Broad Oak AHB Level Crossing

Level Crossing Risk Assessment Report

BS408/001/D420.2

Revision F

Figure 2-35 - Proposed Widening of the Carriageway to the North of Broad Oak Level Crossing

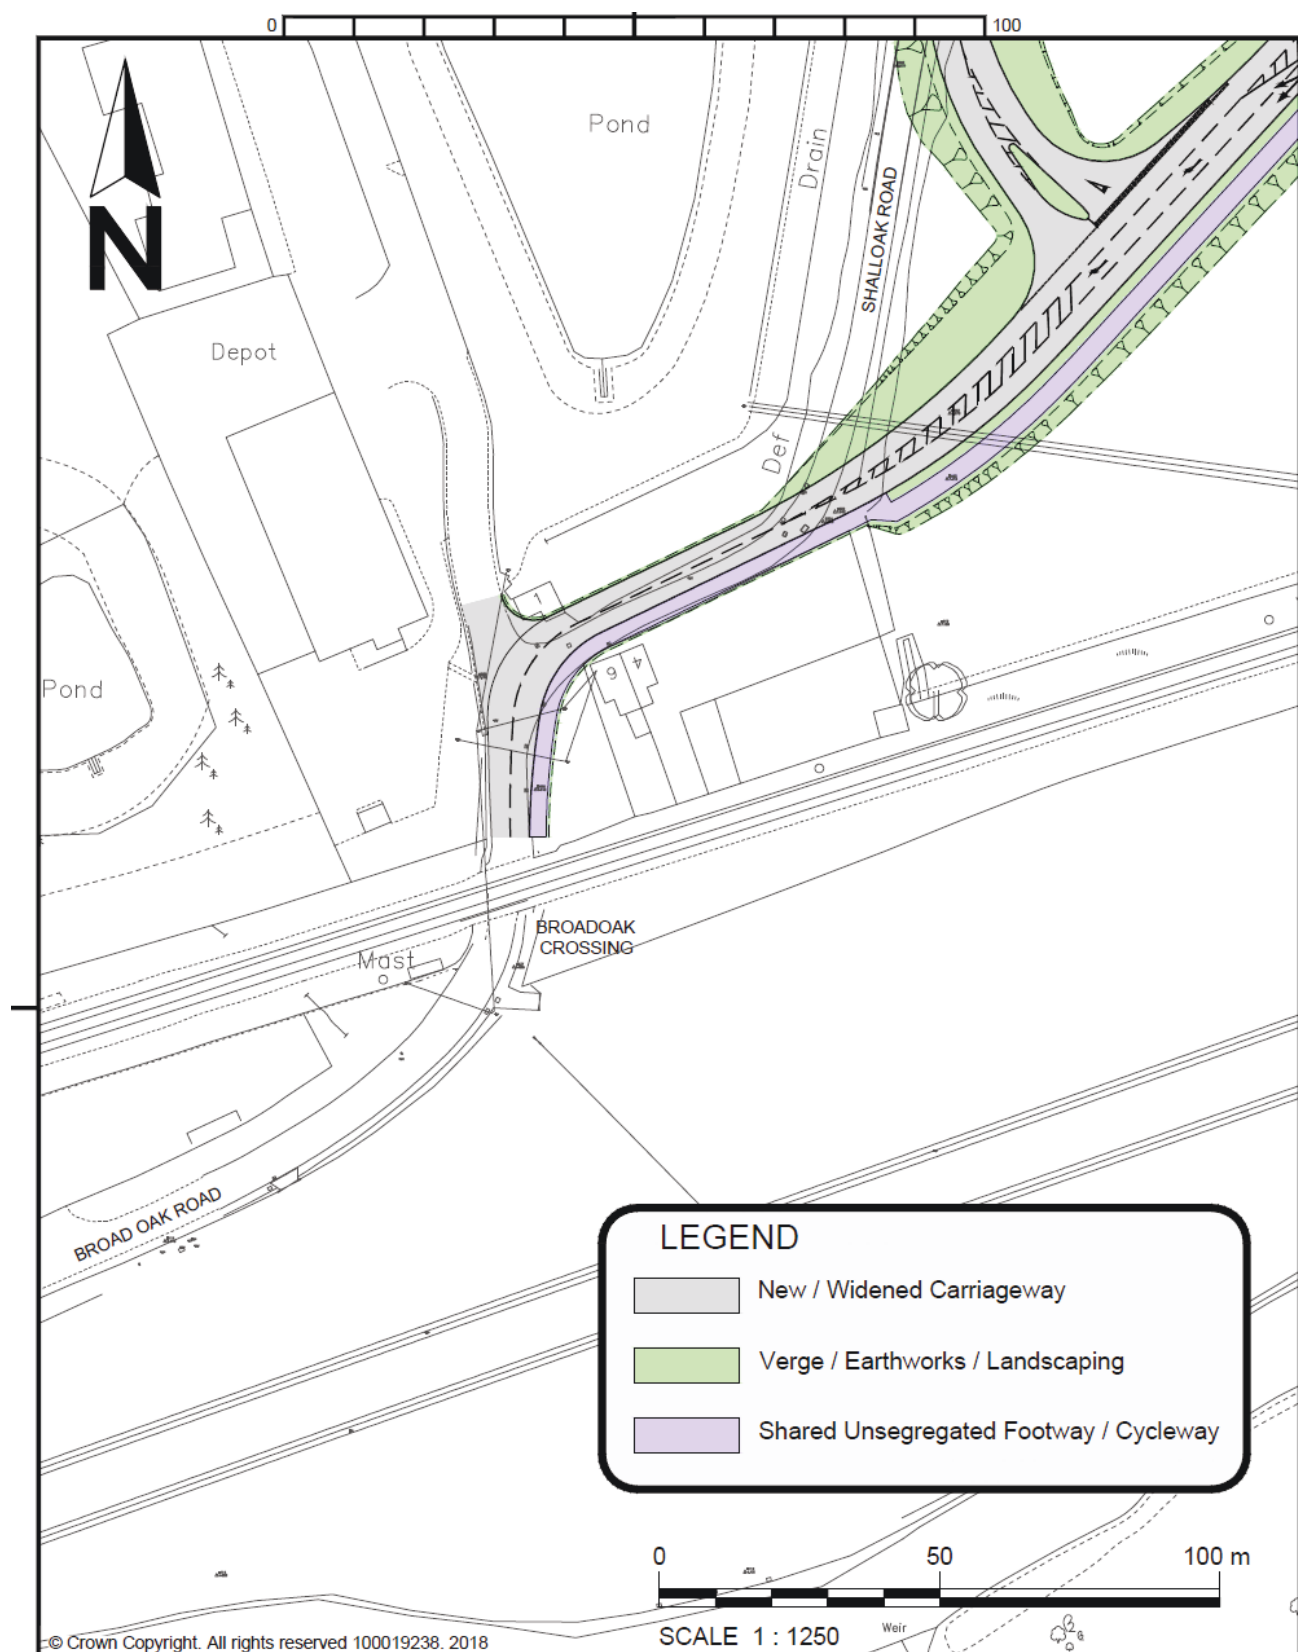
The Meeting reviewed the proposed plan for widening the road to the north of Broad Oak Level Crossing, shown in Figure 2.35. It was noted that although not required by the new layout, the current 7.5 Tonne weight limit would be retained under the new plan, and this would be enforced by physical barriers at the opposite end of the road, at the proposed new roundabout. The Meeting agreed that the blocking back on the north side which was identified at the first workshop would be resolved by the planned road widening.

- The Workshop were notified by Kent County Council that the widening proposal for the North approach to Broad Oak Level Crossing has not been formally accepted by Network Rail, although planning consent was granted in September 2021. The Workshop noted that Kent County Council are to provide a copy of the latest interim widening proposal to Network Rail for approval.
